**Addendum letter to Nepean Green Crime Prevention through Environmental Design (CPTED) Assessment, prepared July 2012**

**1.1 PROPOSED CHANGES TO PREVIOUS SCHEME**

FIGURE 2 – UPDATED RESIDENTIAL COMPONENT OF THE PROPOSAL ON THE SOUTHERN END OF SITE

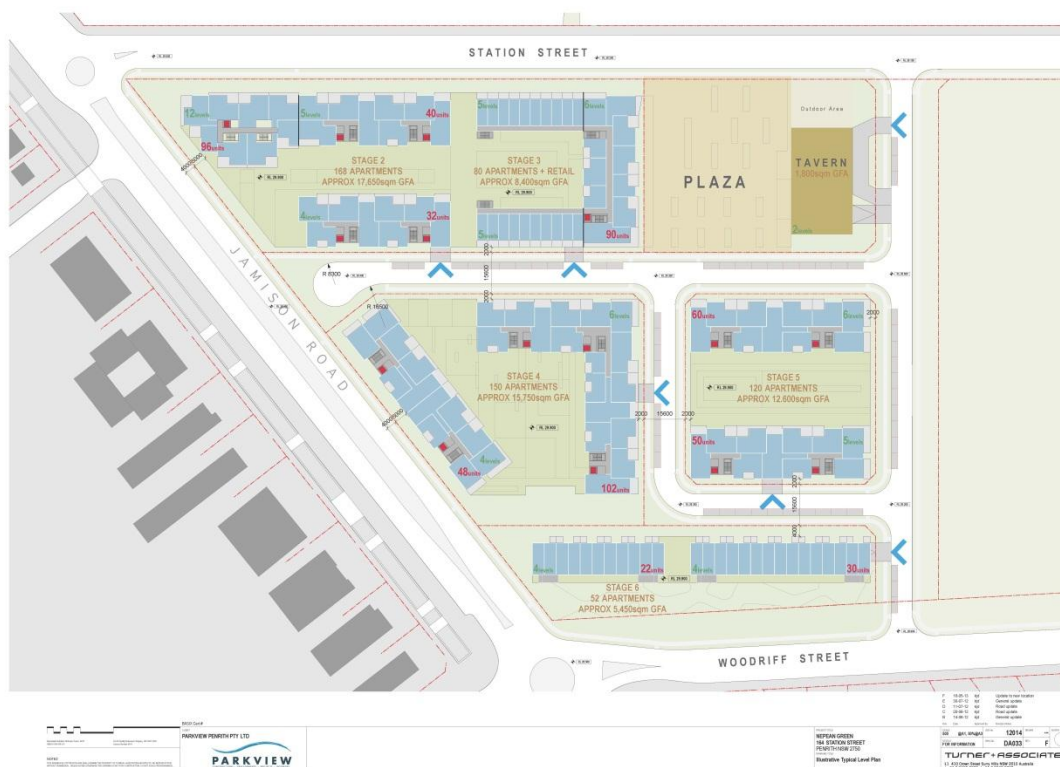
- It will be important to ensure that pedestrian entrances and pathways to private residences in the residential component of the site are clearly delineated from public pathways using appropriate signage, landscaping and lighting.
- All existing recommendations remain valid and should be implemented in full.

- Lighting of internal streets in the residential development should be considered, given that they are not wide streets and will have low levels of passive surveillance due to residential buildings that are designed to predominantly face internal courtyards, and low levels of traffic flow, apart from residents and their visitors.
- The new configuration benefits from placing the car parking and service roads of Masters adjacent to the high wall separating the site from Central Nepean. There is less of a requirement to light this area however active surveillance of the Brigade Access entry should be considered to deter potential infiltration, and concealment of potential criminal elements, along the Brigade Access Road.
- All existing recommendations remain valid and should be implemented in full.

- The proposed internal road in the residential component of the development should be well landscaped, signposted and integrated into local public open space so that it is clear that the road does not follow through to Jamison Road for pedestrians and road users. Good landscaping will also ensure that the area does not appear neglected and does not become an area for loitering.

- Significant landscaping and embellishment of the dead end street to Jamison Road in the residential component of the development will assist to reduce opportunities for crime and loitering in a part of the development that is otherwise unlikely to benefit from much passive surveillance.

FIGURE 3 – UPDATED MASTERS HOME IMPROVEMENT STORE PROPOSAL ON THE NORTHERN END OF SITE

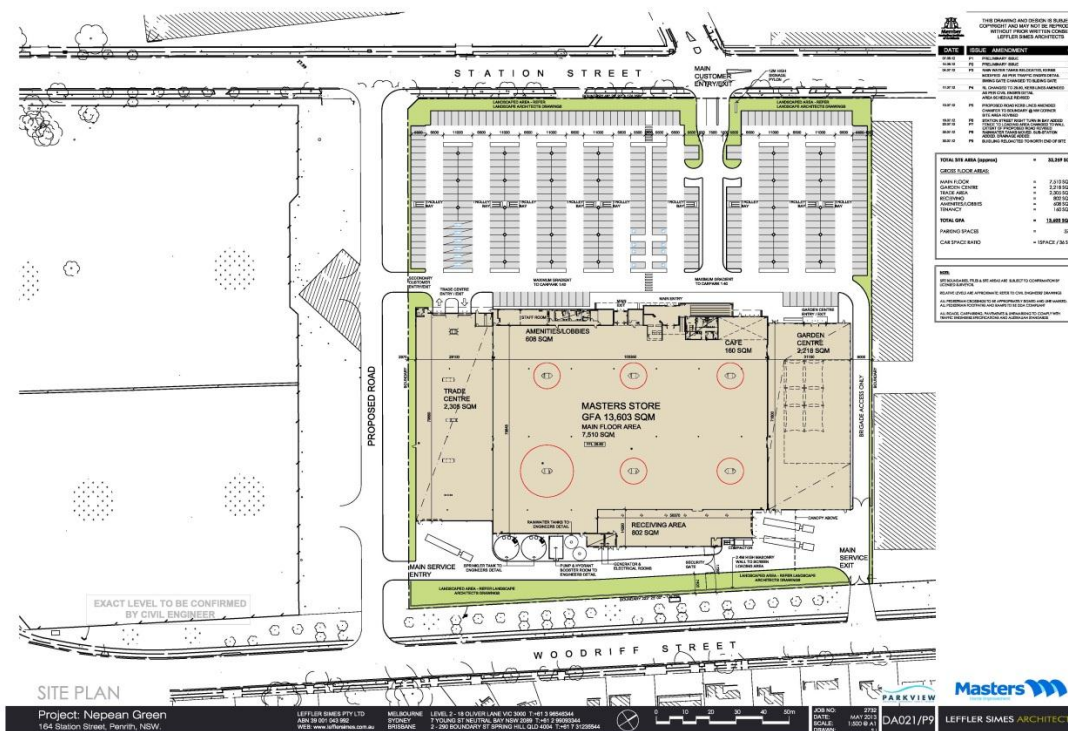
- Proposed access to the car park for the Masters store has changed to be predominantly from Station Street, with another access point proposed on the western side of the proposed road to the south of the site. Service entry is proposed from the eastern side of the proposed road, with service exit to Woodriff Street adjacent to Centro Nepean. The customer parking lot of the Masters store now fronts onto Station Street, similarly to Centro Nepean.

- The location of car parking fronting onto Station Street will expose the site to increased passive surveillance, as Station Street is a busy shopping street further to the north and enjoys high levels of patronage. Proximity to the adjacent Centro Nepean will mean that existing cars and pedestrians on the street create activity on the site, encouraging surveillance. The car parking area will also benefit from a level of passive surveillance from shoppers in the Masters development, particularly at the café which faces onto the parking lot, and patrons of the proposed tavern and plaza on the residential development.

- Service access to Masters is now proposed from the proposed road which dissects the site with an exit via a controlled barrier to Woodriff Street on the eastern side of the retail development adjacent to the Centro Nepean. It will be important that the service loading dock areas are secured, particularly at night, and kept clear to prevent theft of stock or any materials, and vandalism of the external walls of the building. This will be assisted by the control entry doors. Surveillance of the unsecured main service entry will be a requirement during operating hours.
- All existing recommendations remain valid and should be implemented in full.

- If the main pedestrian access points for Masters are likely to be near the vehicular entrances at Station Street and the proposed road. It will be important to ensure that pedestrian pathways are included close to these entrances at a distance that allows for pedestrian safety and provides a safe pathway through the perimeter landscaping to be provided around the outdoor car parking area.

- Opportunities for graffiti or damage to property can be minimised by the use of green walls, landscaping, and good lighting at appropriate times where different uses adjoin, particularly at service entries or roads that are likely to be quiet, such as the Masters store wall adjoining the proposed road to the south, and the Centro Nepean walls adjoining the Masters store site to the north.

- The reconfiguration positions the Masters retail development adjacent to the high wall separating the proposal from Centro Nepean. This reduces the requirement to provide measures to activate this area. The green wall and plantings should be retained from Station Street to the Brigade Access Road to discourage vandalism and improve the interface with the parking bay area. However, plantings of less density are all that would be required on the Brigade Access Road.

- Significant landscaping should be applied to the southern wall of Masters store, adjacent to the proposed road and residential component of the proposal; and the southern wall of Centro Nepean to the proposed Masters parking area and service access path on northern side of Masters store.
